Project	IEEE 802.16 Broadband Wireless Access Working Group < http://ieee802.org/16 >	
Title	Harmonization of DL Subchannelization for WirelessMAN-OFDM	
Date Submitted	2004-11-17	
Source(s)	Tal Kaitz, Ran Yaniv Alvarion Ltd.	tal.kaitz@alvarion.com , ran.yaniv@alvarion.com
	Jon Labs, Rainer Ullmann Wavesat, Inc.	jlabs@wavesat.com , rullmann@wavesat.com
	Ambroise Popper SEQUANS Communications	ambroise@sequans.com
	Shane Rogers Wi-Lan, Inc.	srogers@wi-lan.com
Re:	Comments submitted to P802.16e/D5 Sponsor Ballot.	
Abstract	This document harmonizes the comments submitted to the P802.16e/D5 Sponsor Ballot pertaining to DL Subchannelization for WirelessMAN-OFDM. The intent is to fix errors, clear ambiguities and clarify the operation of this feature.	
Purpose	Consider recommended corrections in Ballot Sponsor Resolution.	
Notice	This document has been prepared to assist IEEE 802.16. It is offered as a basis for discussion and is not binding on the contributing individual(s) or organization(s). The material in this document is subject to change in form and content after further study. The contributor(s) reserve(s) the right to add, amend or withdraw material contained herein.

Harmonizatio

Figure 1***Suggested Remedy***

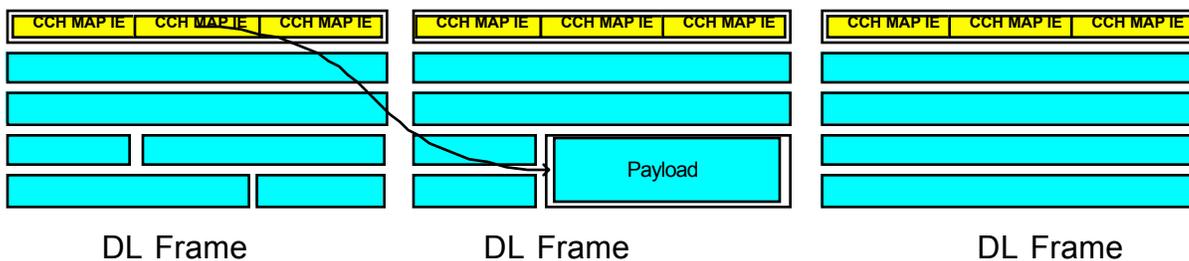
Issue #1: Precision on embedded IEs in the CCH burst (tied to comment 1058)

It is not clear from the text how the embedded MAP elements are used. As an SS cannot demodulate more than 1 burst per frame, when it is demodulating a CCH, it cannot demodulate any data bursts addressed to it. The principle is therefore that the SBCH_DL_MAP_IEs contained in the CCH only describe allocations in future frames. In all frames where bursts are allocated to a given SS, the BS shall assume that the SS cannot demodulate the CCH at the same time and therefore not put any SBCH_DL_MAP_Ies pertinent to that SS in the CCH of that particular frame. Apart from the frames in which it has allocated bursts, an SS shall always demodulate the CCH. The concept is illustrated in Figure 1.

A BS shall assume that the MSS is not capable of receiving more than one burst in a single frame. Therefore downlink allocations contained in SBCH_DL_MAP_IEs in the CCH shall point to future frames. When an allocation is present for a given MSS, the BS shall assume that the MSS may not be capable of demodulating the CCH in that frame, and therefore not include any SBCH_DL_MAP_IEs or SBCH_UL_MAP_IEs for that MSS.
